REQUEST FOR CITY COUNCIL ACTION

Approval of Resolution 2021-05 Approving Cherry Grove Major Subdivision

CHERRY GROVE SUBDIVISION

RE: Cherry Grove Subdivision
Plan review comments

PROJECT:	CHERRY GROVE SUBDIVISION
SHEET TITLE:	OVERALL PLAN

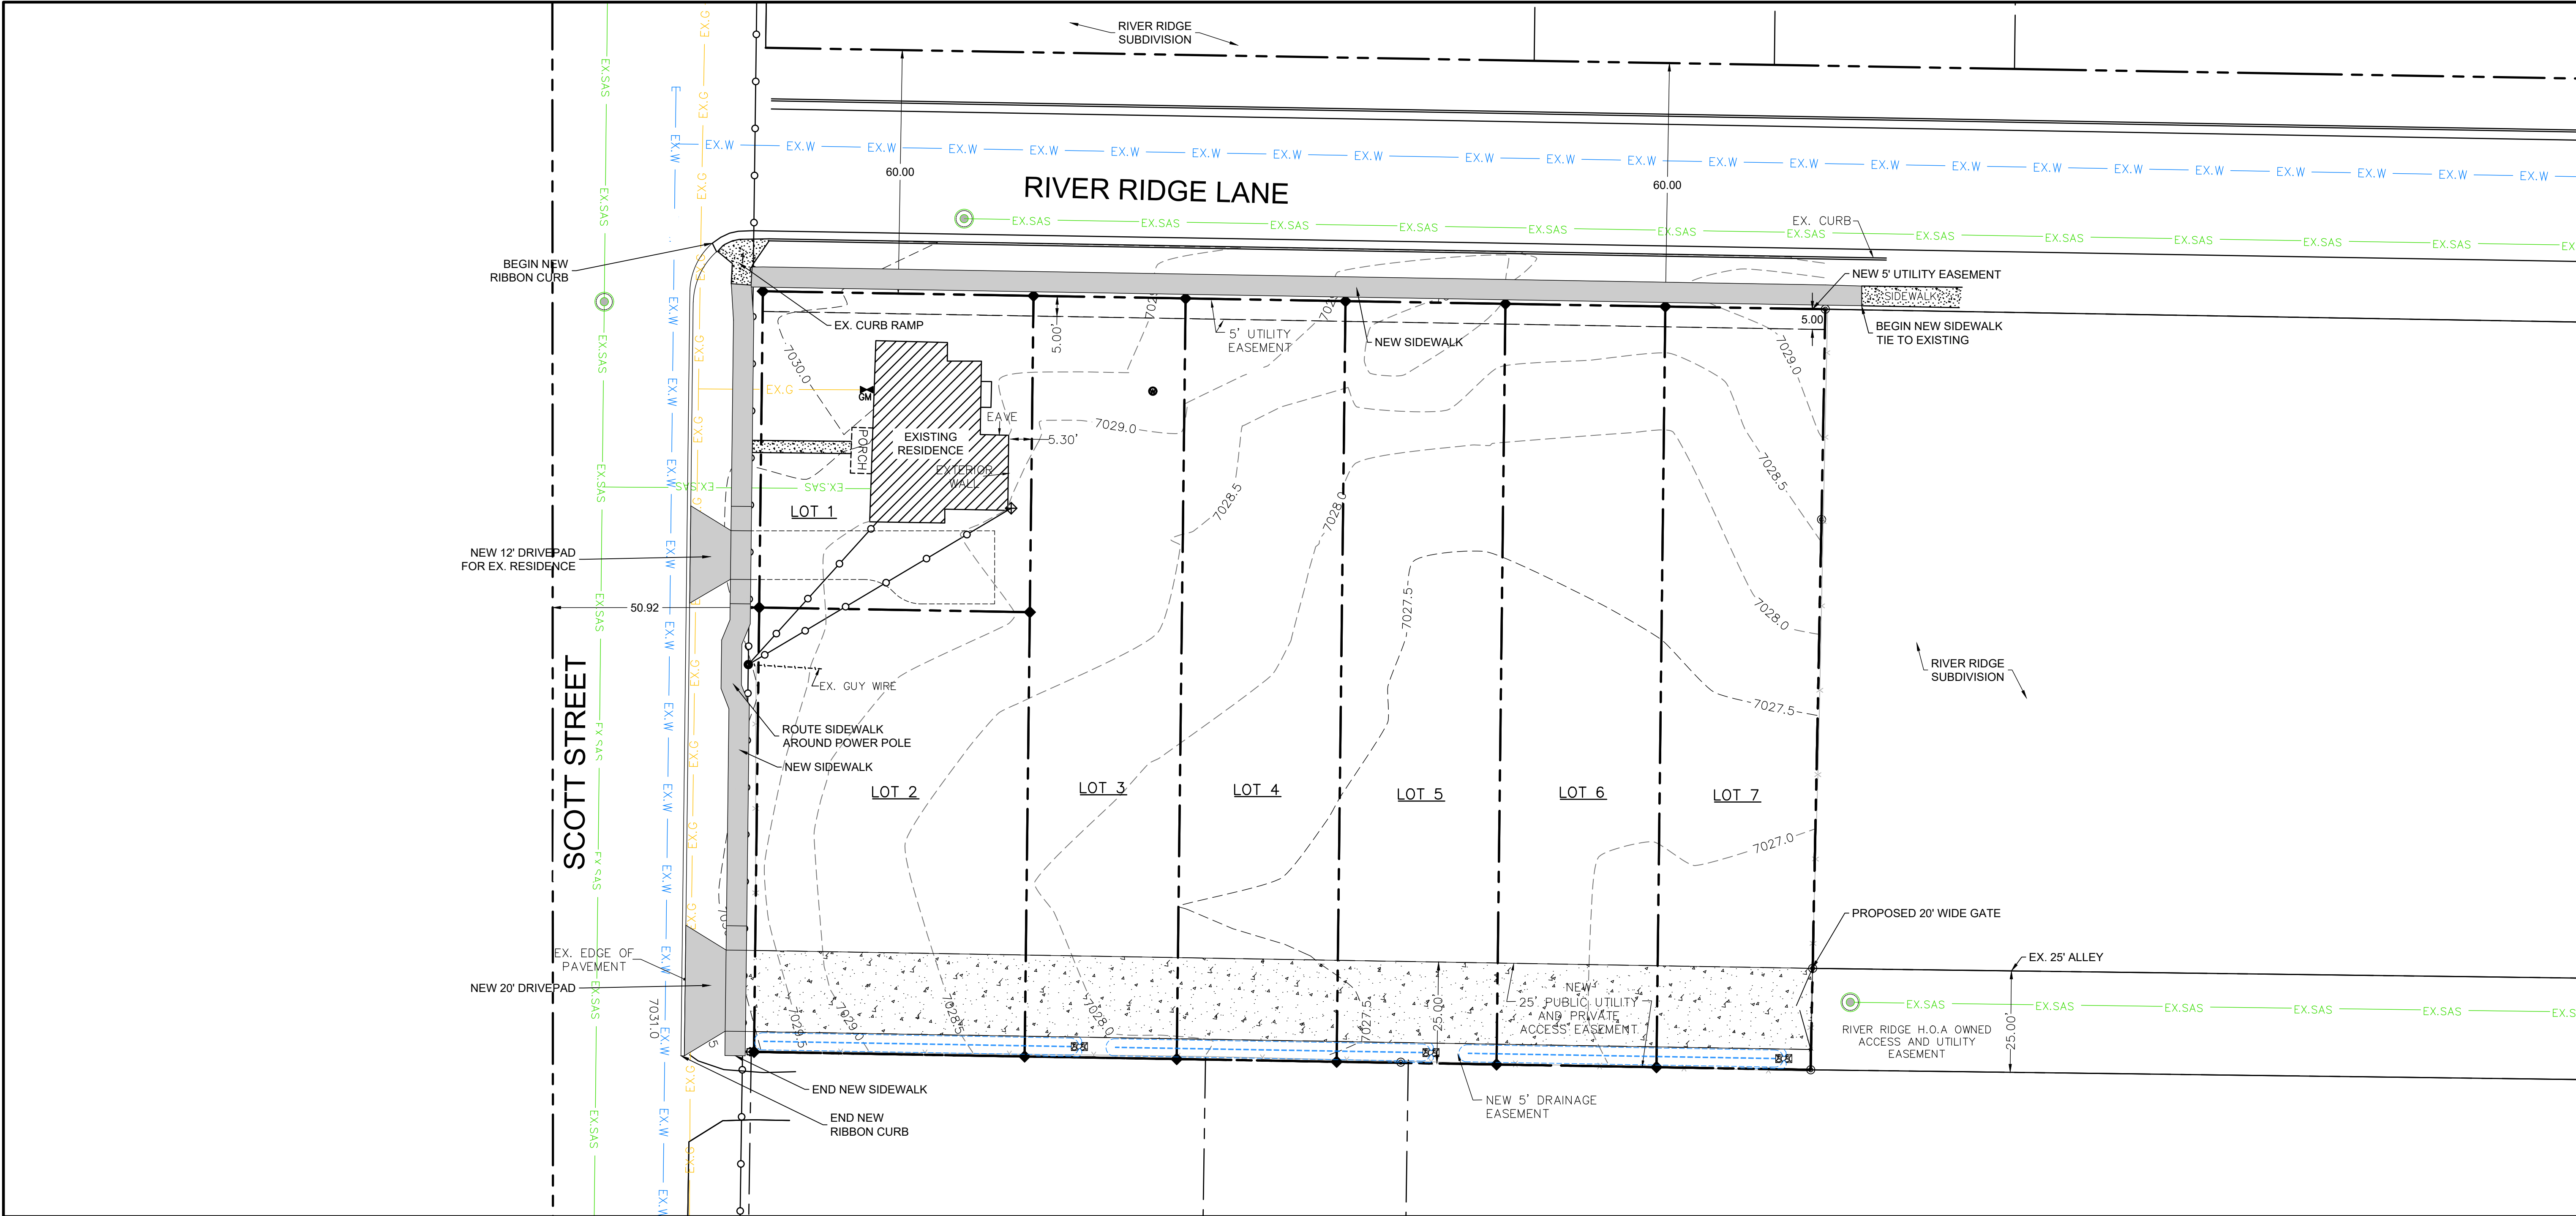
On behalf of Arkansas River Living, LLC, developers of River Ridge Subdivision, I would like to make comments on the Overall Plan submitted for the January 25, 2021 Planning Commission meeting regarding the Cherry Orchard Subdivision at 825 Scott Street.

As we were going through the process of designing River Ridge Subdivision and working with the City, it was suggested that we align our alleys with the south edge of the adjacent property line (825 Scott Street), so that future development of that parcel would extend the alley to Scott Street. We believe that is still the best plan, and ask that the Planning Commission consider recommending this change.

This change eliminates curb cuts along River Ridge Lane, which would be consistent with the remainder of that section of River Ridge Lane.

In looking at the submitted Plan for Cherry Orchard Subdivision, it appears that the northern edge of the proposed easement, closely aligns with where the alley would pass through. This change would eliminate the proposed gate, and also ensure that the sewer main, when extended, is not impeded by future improvements. Although structural improvements would be prohibited by an easement, easements are not always adhered to by homeowners over the course of time (shed's etc.), which obviously can cause maintenance issues for the City.

In summary, we believe that extending the River Ridge Subdivision alley through to Scott Street is a cleaner, overall better plan for the City, and for the residents.

SHEET TITLE:
SCOTT STREET PLAN AND PROFILE

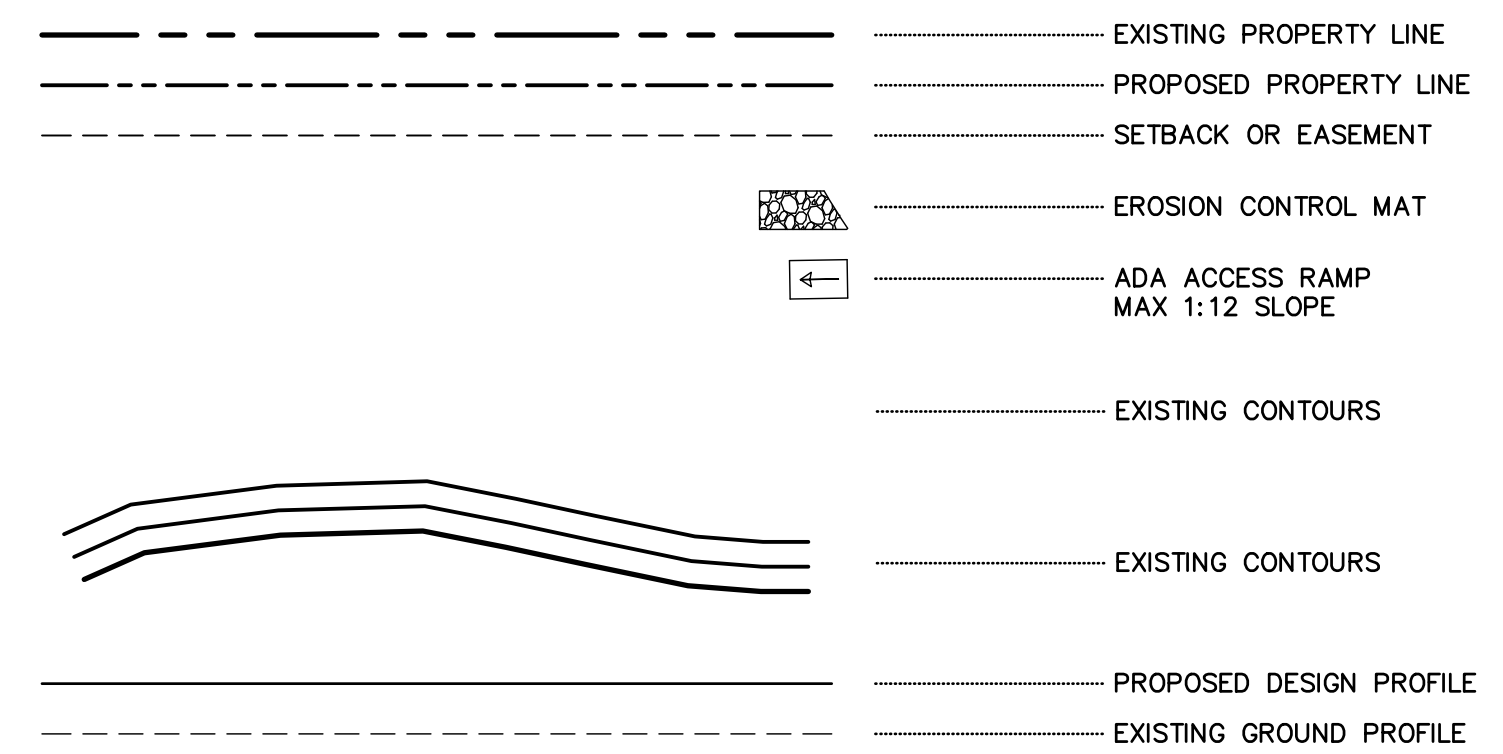
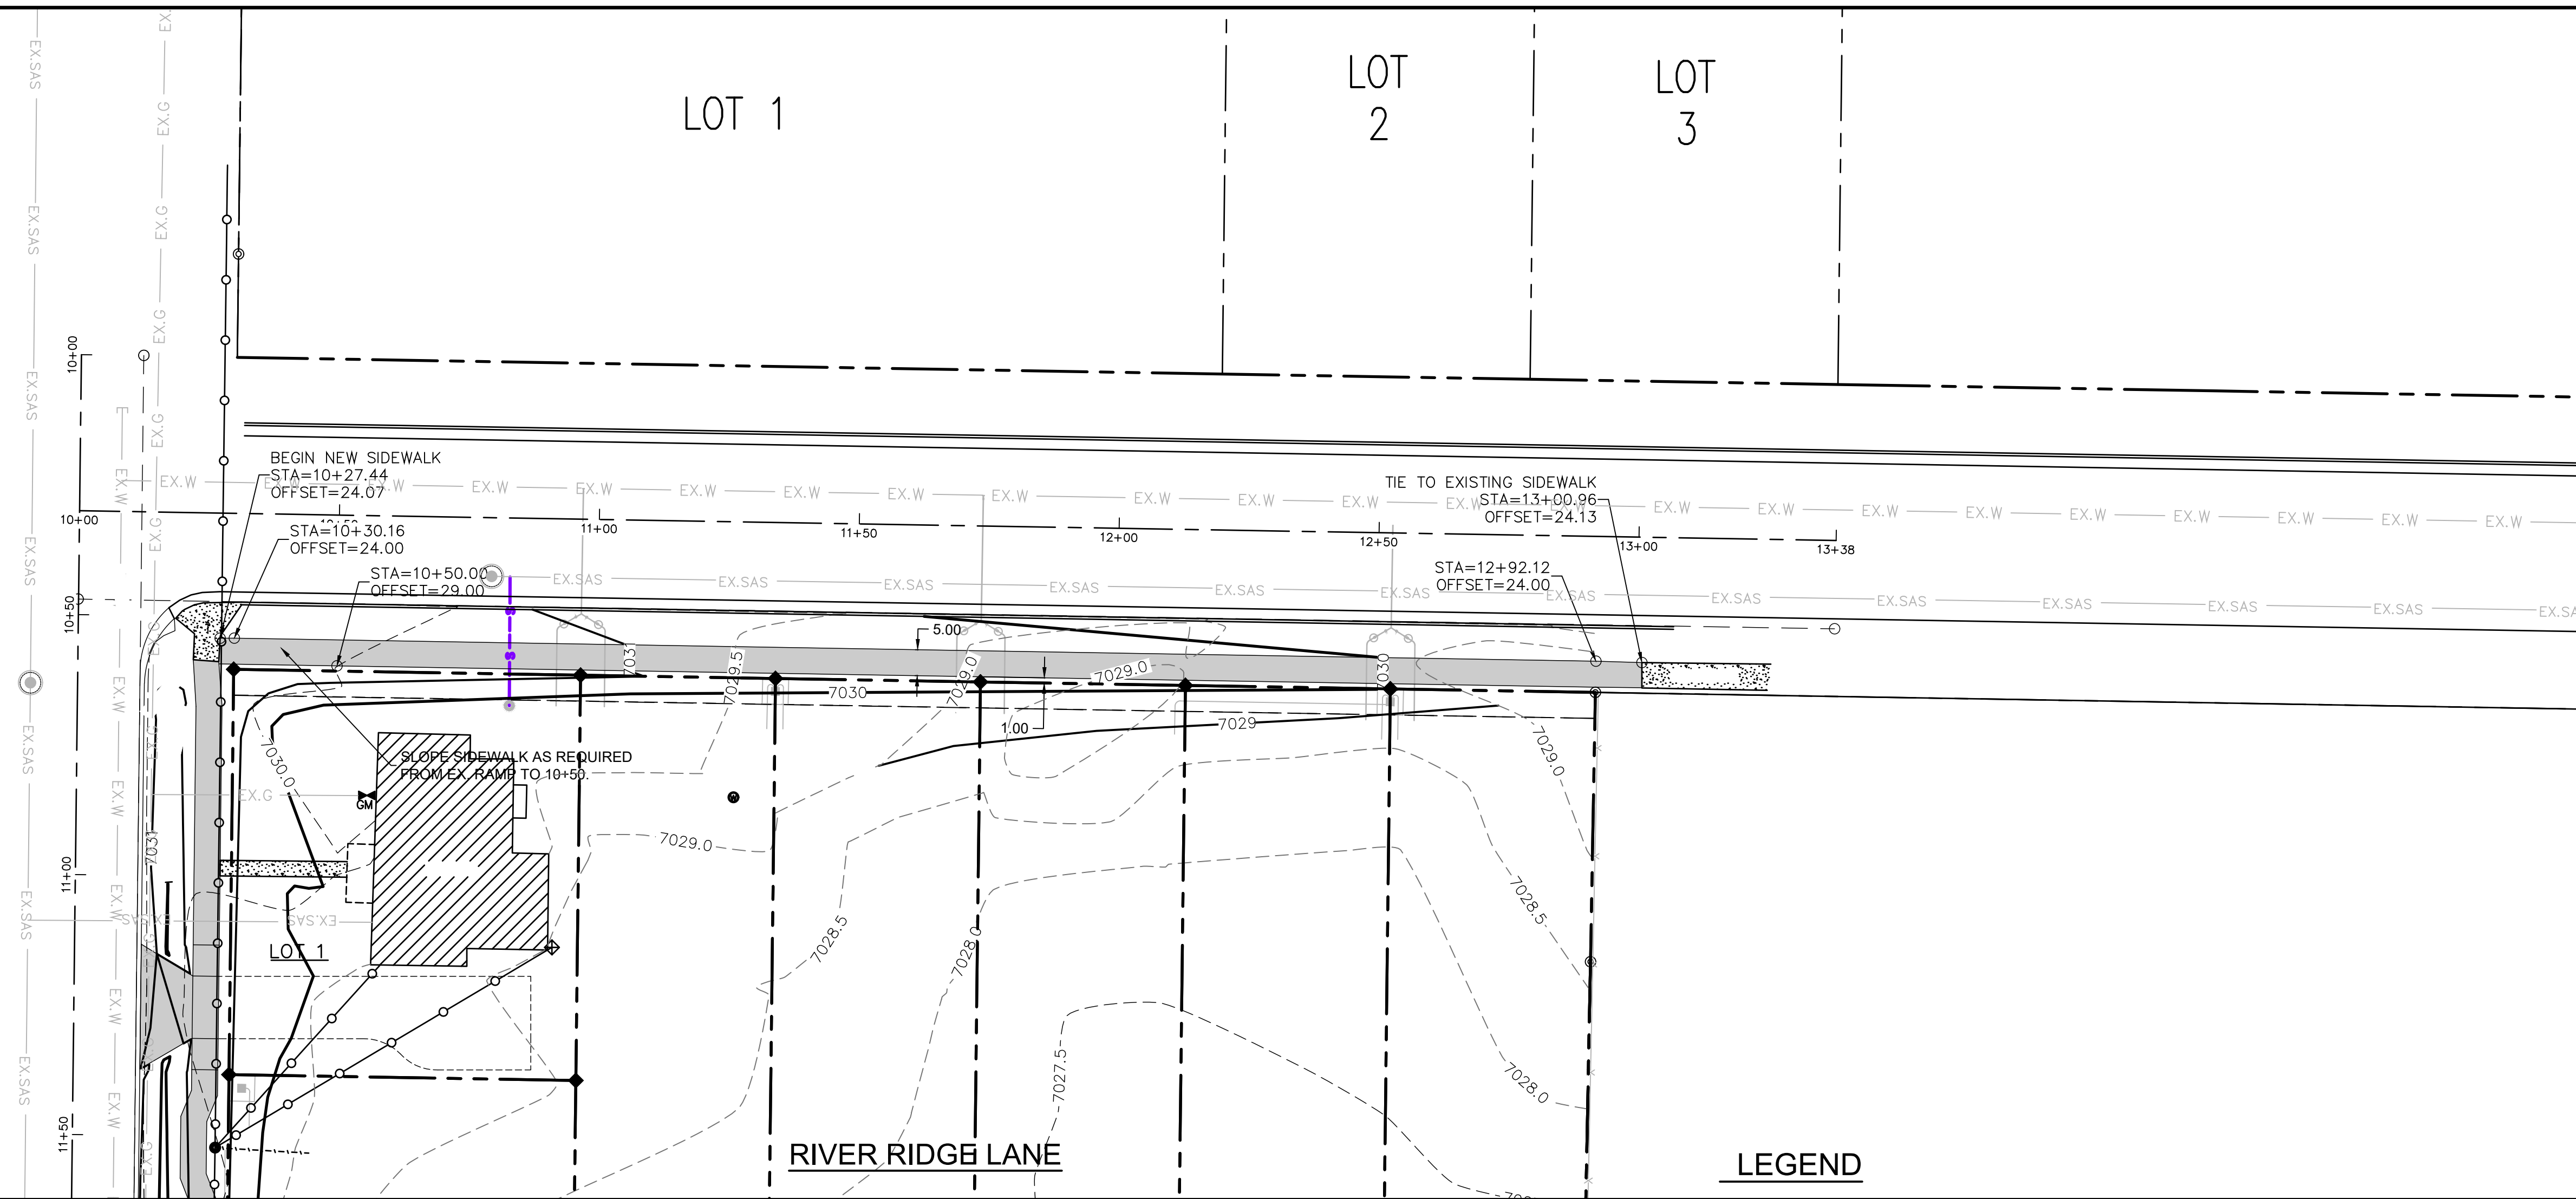
- Scott Street and River Ridge Lane are existing streets.
 - The applicant is required to either improve Scott Street or the subdivision improvement agreement will allow the option of providing funds for the construction of Scott Street adjacent to the subdivision, versus construction of the 187.47 foot segment. This determination shall be made by the Public Works Director.

2. Prior to the recording of the subdivision plat, the applicant shall enter into a subdivision improvement agreement that guarantees the construction of the public improvements that are required for the project. The subdivision improvement agreement will allow the option to construct Scott Street adjacent to the project or have the applicant provide a fee equal to the estimated cost of the street segment for construction at a later date. This determination shall be made by the Public Works Director.

2. Prior to the recording of the subdivision plat, the applicant shall enter into a subdivision improvement agreement that guarantees the construction of the public improvements that are required for the project. The subdivision improvement agreement will allow the option to construct Scott Street adjacent to the project or have the applicant provide a fee equal to the estimated cost of the street segment for construction at a later date. This determination shall be made by the Public Works Director.
